SUBJECT: James A. FitzPatrick Nuclear Power Plant
Docket No. 50-333
**Request for Additional Information Regarding the Reliability of
Manual Bus Transfers Between Onsite and Offsite Power Supplies**

RESPONSE TO NRC QUESTIONS

JAMES A. FITZPATRICK NUCLEAR POWER PLANT
Docket No. 50-333

FIG. 3

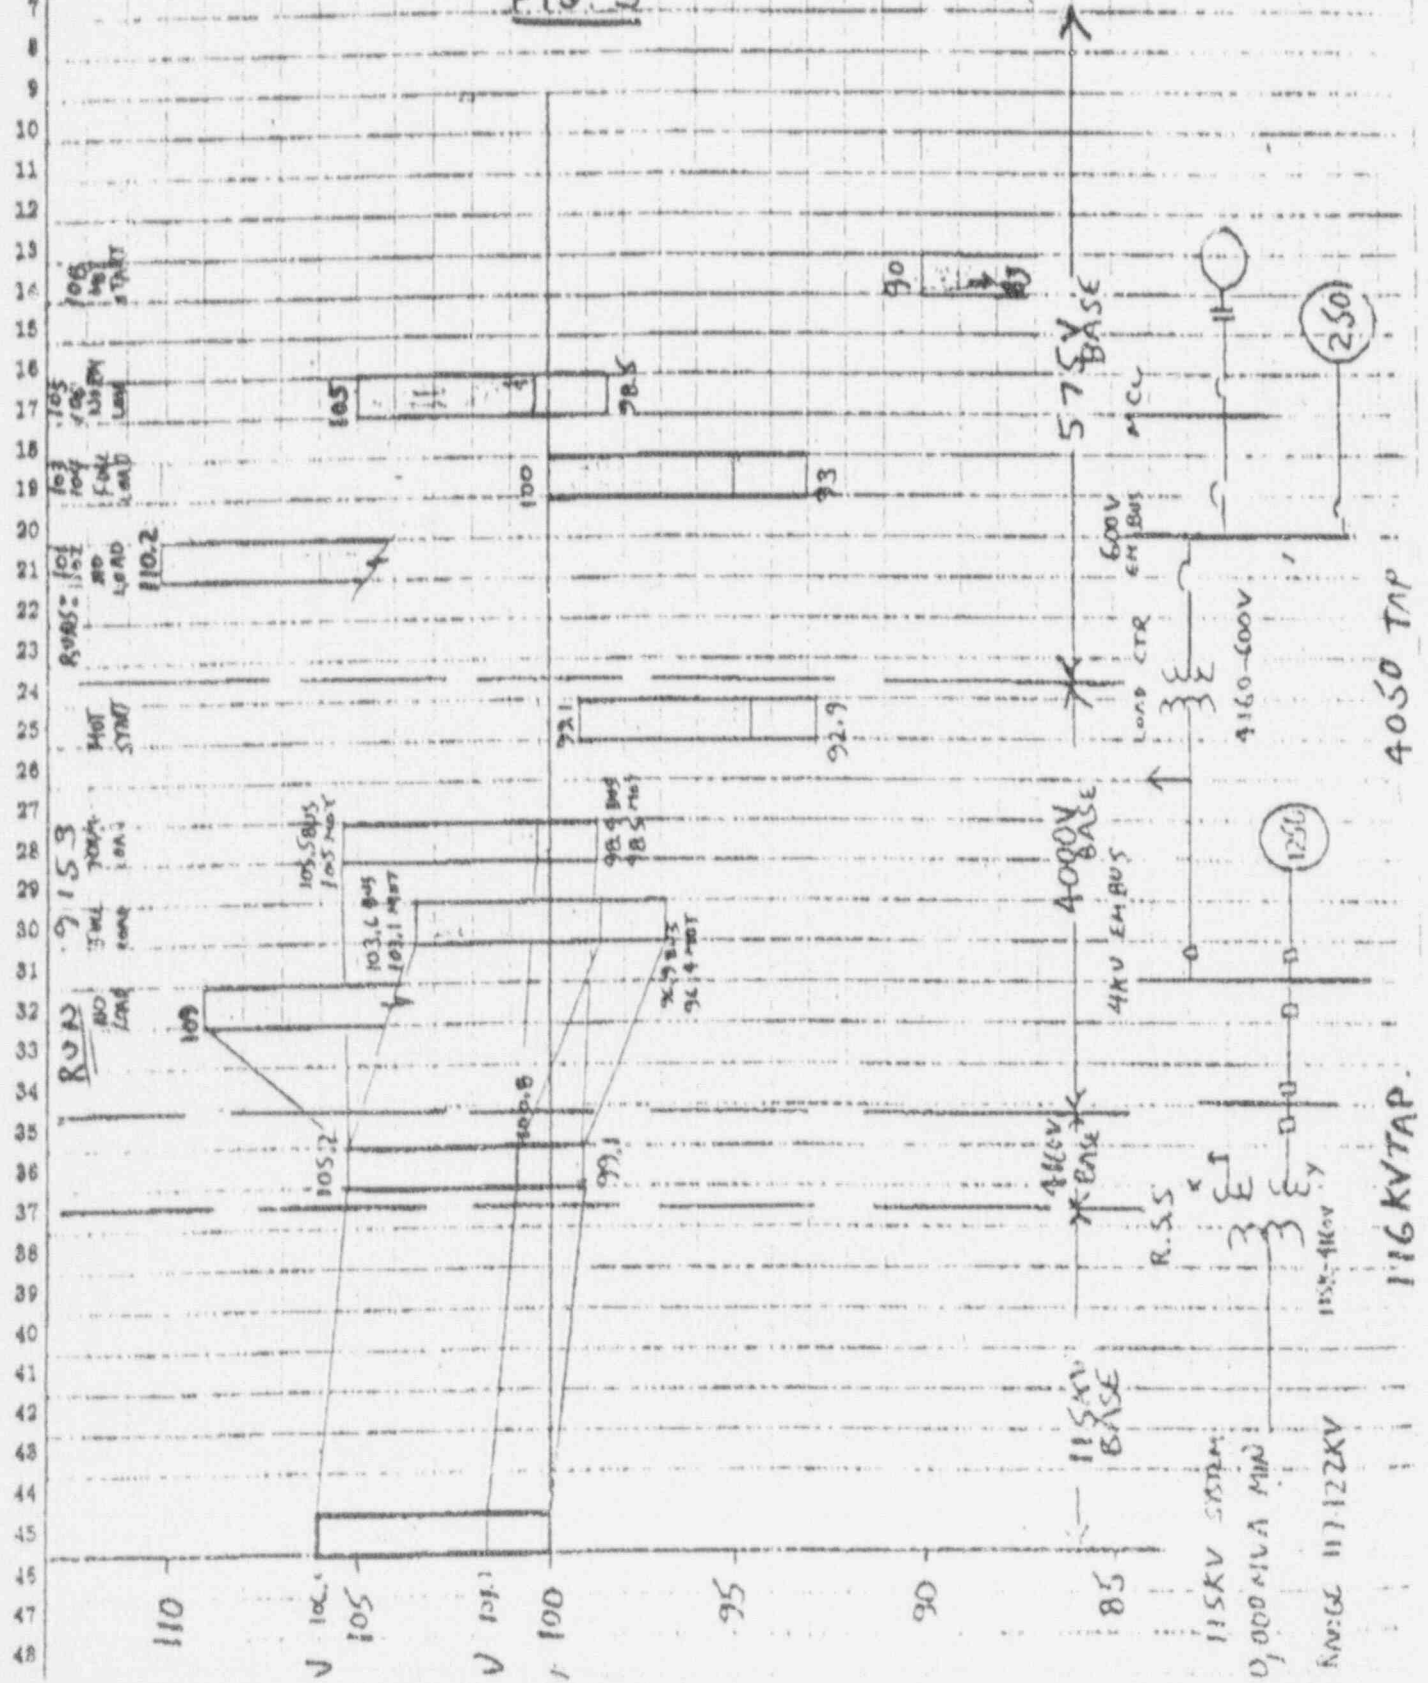
- a. Motors rated at 575 volts are powered from the 600 V buses at the FitzPatrick facility. Motors are usually rated for continuous service over a range of 0.90 pu to 1.10 pu of their rated voltage. When the offsite Preferred Power System (PPS) is at 122 kV, the 600 V buses are at 648 V which is 1.13 pu. Neglecting any tolerance contributions, this exceeds the allowed 1.10 pu. Under some conditions e.g., when the motor load is less than rated, this excess could be acceptable; however the licensee must provide justification to support the adequacy of the FitzPatrick design.

- d. It appears that, in attempting to avoid transient low voltages, NYPA may be continuing the practice of allowing 1.13 pu as a potential steady state motor voltage while attempting to minimize low voltage conditions in parts of the distribution system.

Run 9153 of calculation 14620-E-77 shows the present configuration for the 115 kV to 4 kV transformation. At no load and 122 kV on the 115 kV bus, the 4 kV bus is at 1.09 pu (4360 V) on 4 kV base (See page 6, Figure 3 and data on pages 12 through 15). Run 101 show the 4 kV to 600 V transformation at no load (See page 6, Figure 3 and data on page 16). The theoretical no-load, motor running voltage would be 633.65 V (1.102 pu) on the 575 V base. While the 1.10 pu standard is exceeded, this condition exists only under unrealistically low or no-load conditions. With any loading on the 600 V bus, the motor terminal voltage would drop below the acceptable 1.10 pu upper limit.

The Part a response shows that the Authority does not operate motors at 1.13 pu. Under no-load conditions with a grid voltage of 122 kV only 1.102 pu (575 volt base) exists. See response to Question 1, Part a.
